## Information Request

<b>Application no:</b>	MCU26/0037
<b>Assessment no:</b>	0207027
<b>Proposal:</b>	Short-term Accommodation (100 Rooms) and Food and Drink Outlet
<b>Street address:</b>	52 Gregory Street NORTH WARD QLD 4810
<b>Real property description:</b>	Lot 2 RP 718777 Lot 1 RP 718777
<b>Applicant's reference:</b>	NP25.336

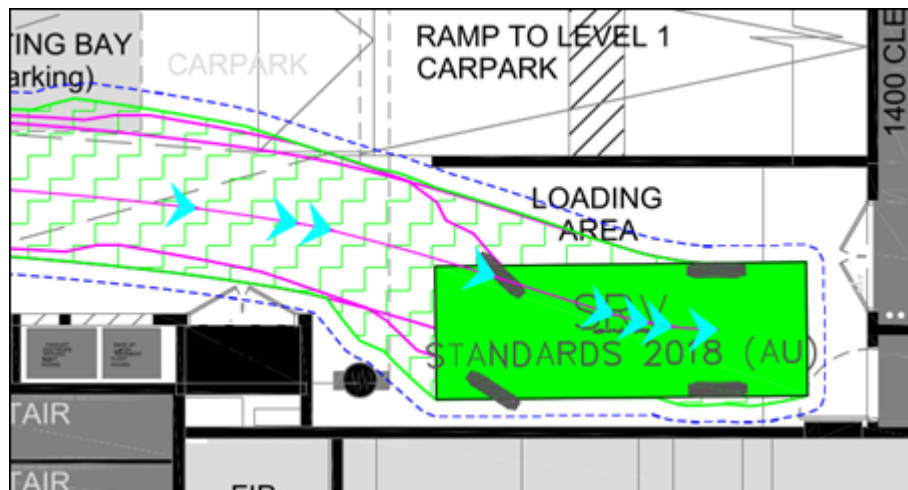
- D. Ground Level Waiting Bay for Single Lane Ramp
- (a) Relocate the after-hours gate further into the site, such that a vehicle waiting for the gate to open can sit within the ramp waiting space and not be required to wait within the street or footpath.

- (b) Revise the layout so that the marked waiting area/stop bar corresponds with the waiting space location assumed in the swept path diagram, and preferably supply additional manoeuvring area to minimise the likelihood of an exiting vehicle hitting the end of the adjoining loading area wall:
